BASIC ASSESSMENT FOR THE PROPOSED IRT PHASE 2A TRUNK ROUTE: PORTION E1, 3.5KM OF GOVAN MBEKI ROAD, MANENBERG & GUGULETHU: FOCUS GROUP MEETING WITH CITY OF CAPE TOWN REPRESENTATIVES

PRE-APPLICATION REFERENCE NUMBER: 16/3/3/6/7/1/A2/19/3028/18

MINUTES- FINAL

Figure 1 Proposed Wetland Encroachment for the Western Component (source: Final Basic Assessment Report, Environmental Partnership, 2017)

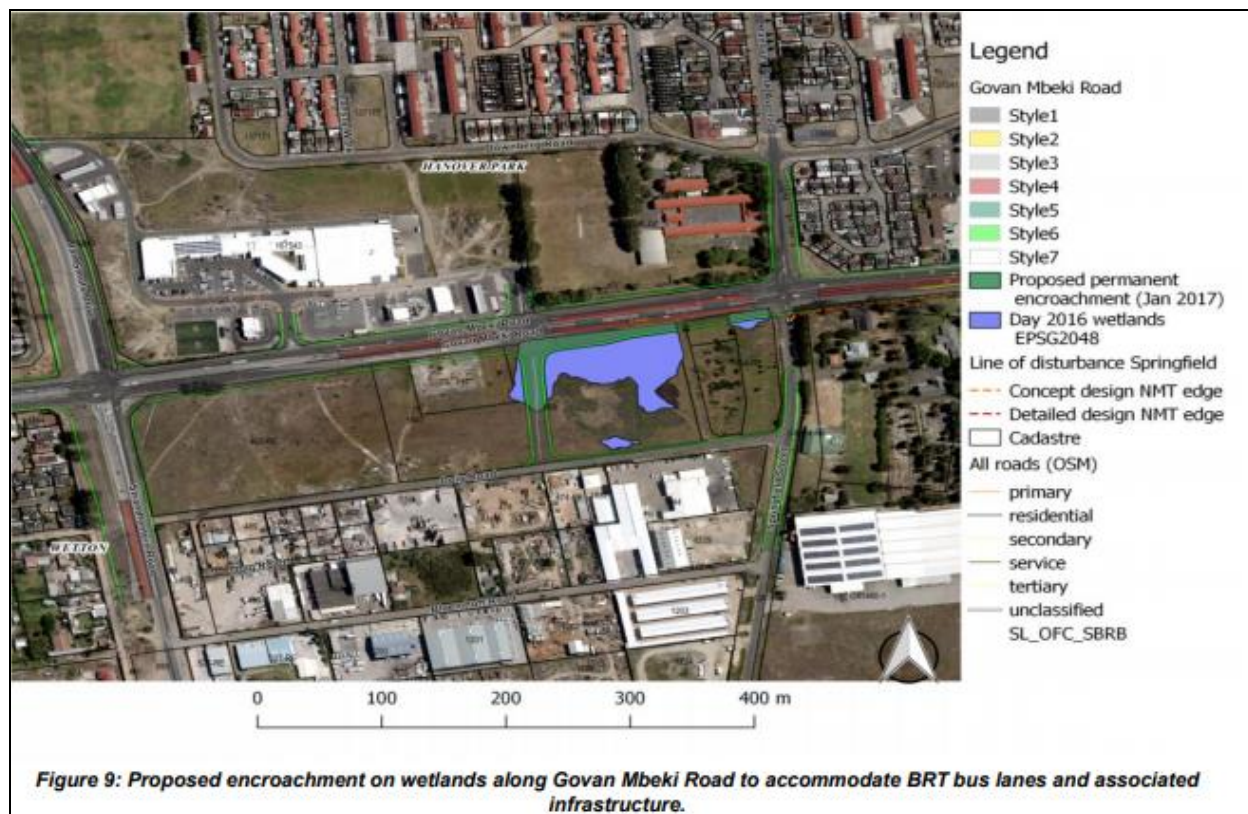
- b) MP indicated that contact had been made with the DWS, but that their feedback remained outstanding.
- c) RS noted that, as far as he could recall, an offset was recommended for the west which required the rehabilitation of a particular wetland along the route, however that this was later changed to the provision of rehabilitation within the Edith Stephens Wetland Park.

- d) AP stated that offsetting the wetland would be significant and that it is important to make the proposal environmentally and hydrologically viable.

- e) MP confirmed that she would review the Basic Assessment Report for the western component of the IRT route to ascertain the offset requirements therein and the motivation behind them. She added that similar recommendations would be made as part of the E1 Basic Assessment process, if appropriate. **Post-meeting note:** Based on the Final Basic Assessment Report written by Environmental Partnership, it was found that a portion of two wetlands would require infilling (refer to Figure 1) and that a section of the Big Lotus River would be affected. The present ecological status of all freshwater bodies was considered to be low, however the conservation status of the Big Lotus River was ascribed a medium rating, given its location upstream of the Zeekoevlei Ramsar wetlands. The ecological significance of the loss of the wetlands is considered to be of "medium negative significance – a rating that takes account of the existing level of degradation and fragmentation of the system, but also of the rapid rate of degradation of Cape Town's wetlands" (Day, 2017). The particular nature of the ideal offset (i.e. the rehabilitation of some of the Edith Stephens Wetland Park), which was ultimately recommend, was achieved through the receipt of comments from Dr. Patricia Holmes of the City of Cape Town Biodiversity Management branch. This information will be provided to the freshwater ecologist for this Basic Assessment process for consideration.
